TOWN OF PORTOLA VALLEY

MEMORANDUM

RE: Architectural Review and Site Development Permit for a New Pool Cabana and Undergrounding of an Existing Seasonal Creek, File # 40-2017, 199 Mapache Drive, Mainzer Residence

PROPOSED
 CULVERT &
 OVERFLOW SWALE
 EXHIBIT

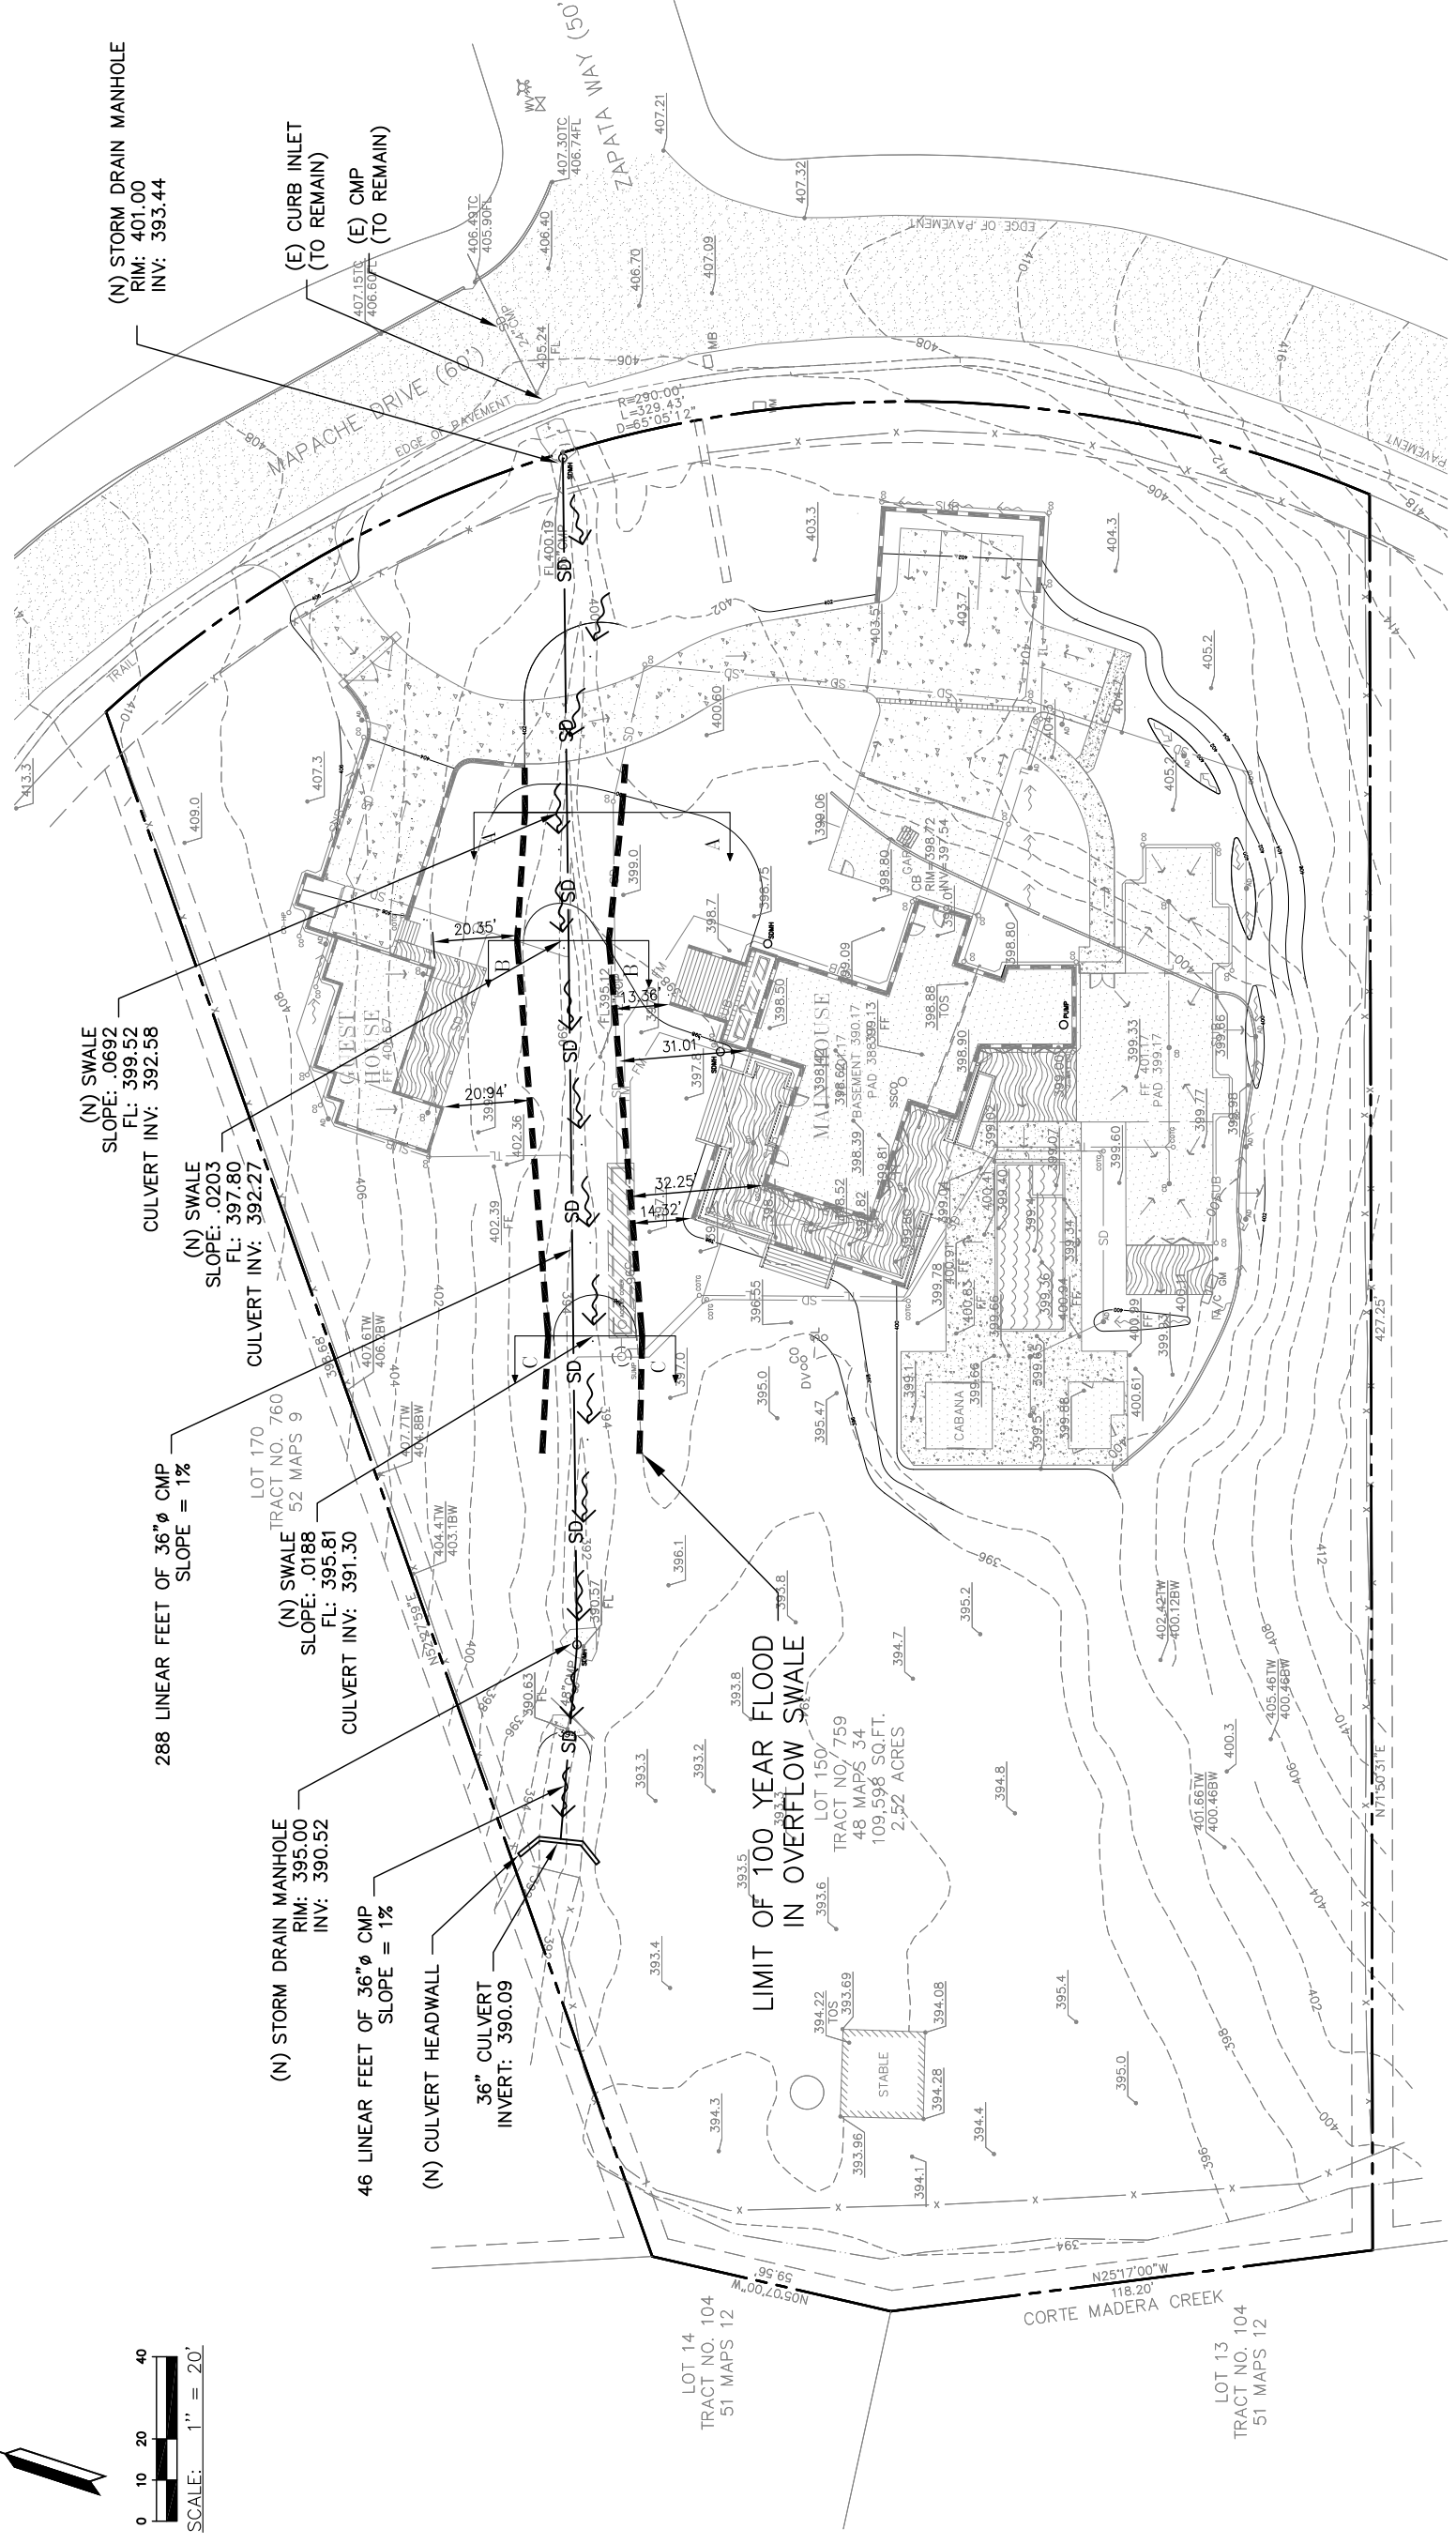
3. The n-value of 0.022 used for the new pipe was less than the normal value per Sheet R-15 in the submittal package. Please use the normal value or submit justification for using the lesser value.
